中西區區內不合標準和缺乏連接的行人路

14 July 2014

Missing and sub-standard pedestrian connections in the Central & Western District

6.

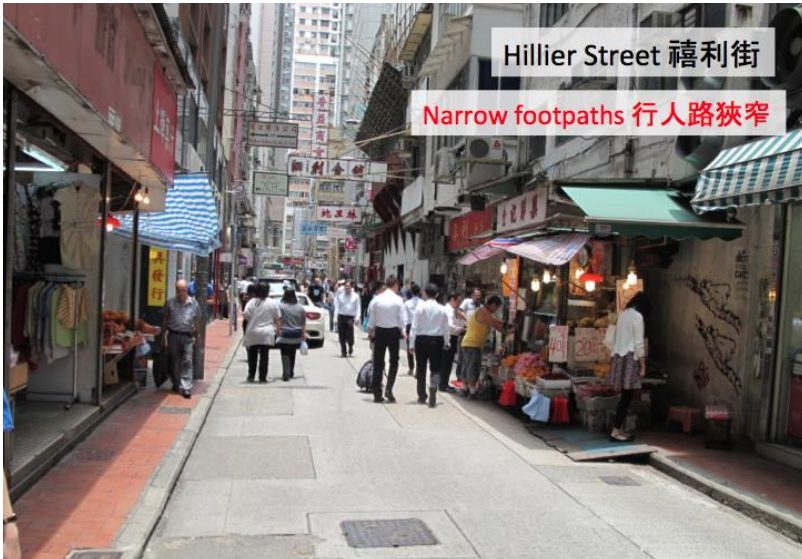
Location: Breezy Path
Problem: Narrow footpath
Description: The traffic flow is high, and the footpath is narrow
Suggestion: Narrow down the footpath of Hong Kong Institute of Technology side and widen the other side footpath

位置: 卑利士道
問題: 行人路狹窄
詳情: 汽車道路比較繁忙，而且行人道狹窄。
建議: 收窄香港科技專上學院旁的行人路擴闊另一方行人路

8.
Location: Chung Kong Road (under Shun Tak Centre)
Problem: Missing footpath
Description: Missing footpath for people running alongside the harbour front
Suggestion: Provide footpath

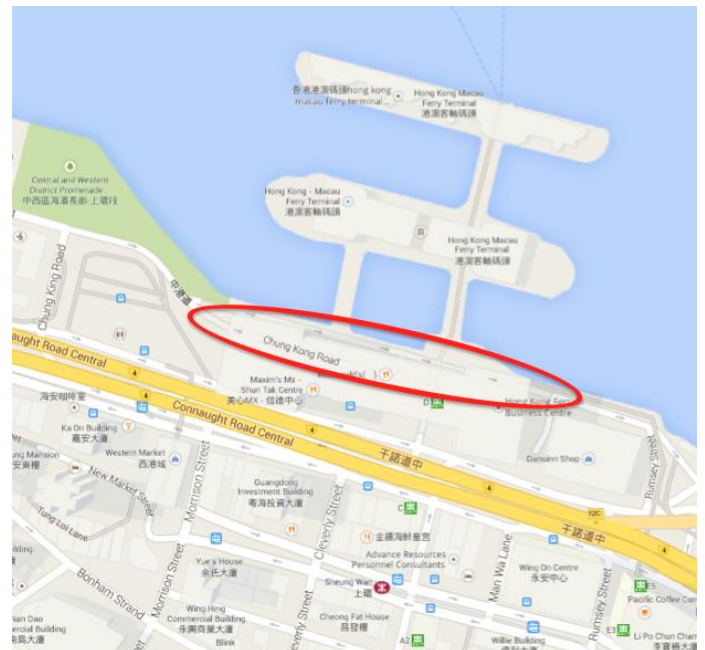
位置: 中港道(信德中心)
問題: 缺乏行人路
詳情: 缺乏行人路予跑步人士沿著海濱跑步
建議: 提供行人路

9.
Location: Queens Road West (near Li Sing Street)
Category: Missing dropped kerb
Problem: Dropped kerb is only present on one side of the road
Suggestion: Provide dropped kerb at one side and 'Look left/right' markings on both sides

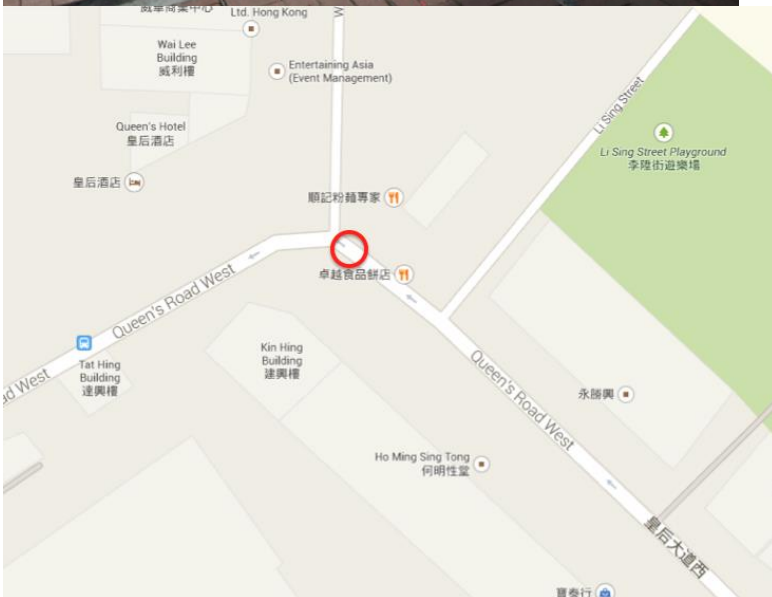
- 位置: 皇后大道西(李星街)
問題: 缺乏下斜路緣
詳情: 只有一邊行人路上設有下斜路緣及行人輔助線
建議: 在對面的行人路增設下斜路緣、並增設道路標記及行人輔助線於兩旁

10.

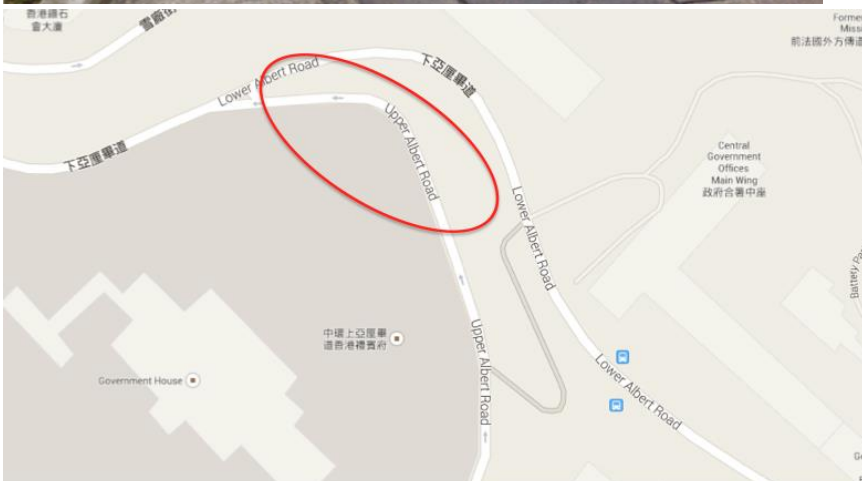
Location: Intersection of Park Road and Lyttelton Road
Problem: Missing crossing
Description: There is a missing crossing from Park Road to Lyttelton Road.
Suggestion: Provide crossing.

位置: 柏道與列堤頓道交界
問題: 缺乏過路處
詳情: 缺乏過路處連接柏道及列堤頓道。
建議: 提供過路處

16.
Location: Connaught Road near Wing Wo Street
Problem: Missing crossing
Description: Missing crossing connection with the bus stop and the refuse collection point
Suggestion: TD to study improvement proposals

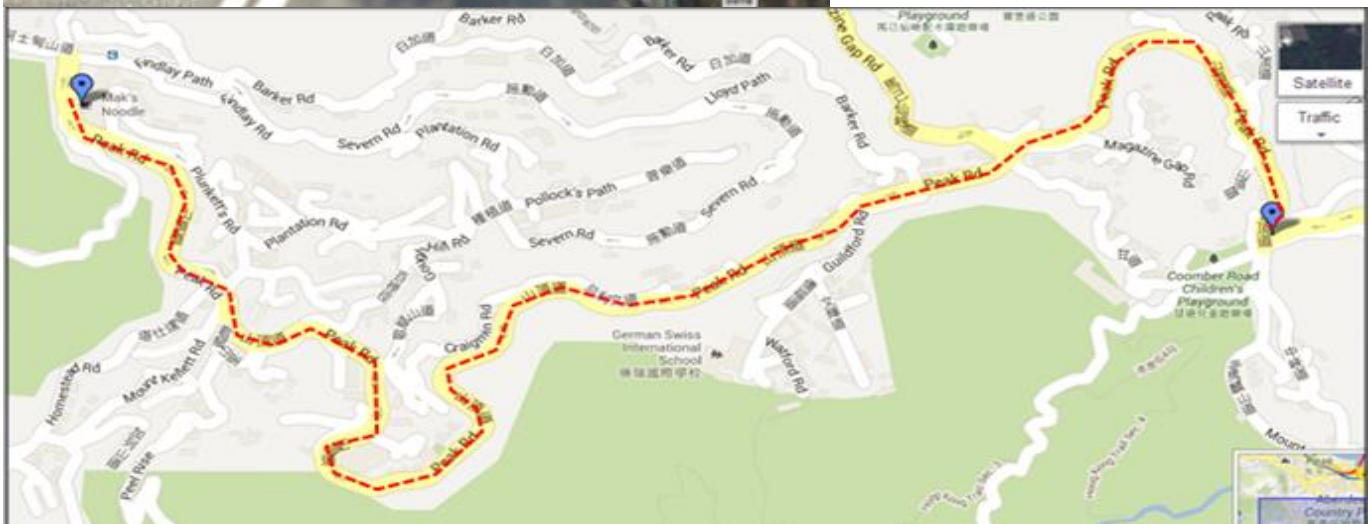
- 位置: 干諾道中旁的永和街
問題: 缺乏過路處
詳情: 缺乏過路處連接巴士站及垃圾收集站
建議: 請運輸署研究解決方法
